## Sun Visor Replacement

Classification	Repair Bulletin	Section/Group	15 - Interior Trim	Country/Region	All
Year	2012-2014	Model	Model S	Version	All

Kigure 2 (First generation sun visor)

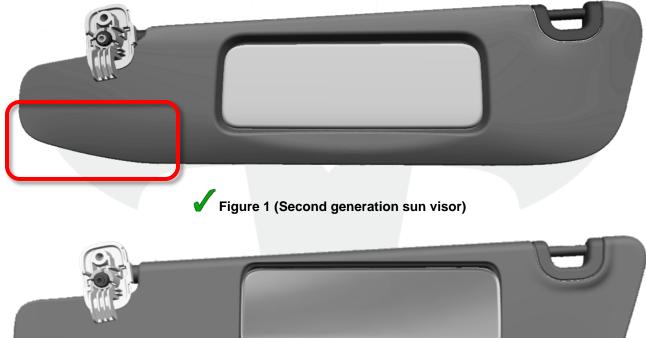
Vehicles built before approximately August 21, 2014 were equipped with first generation sun visors. The first generation sun visors and the attached mirrors are narrow, causing a perceived quality issue. Second generation sun visors are now available. The second generation sun visors have a smaller airbag warning label and are wider with larger mirrors.

- Inspect the edge of the driver's side sun visor below the attachment bracket: 1.
  - If the corner is tapered (Figure 1), the second generation sun visors are already installed. Discontinue work • on this procedure.
  - If the corner is squared (Figure 2), continue to the next step in this procedure. •

Upon customer complaint, replace both first generation sun visors.
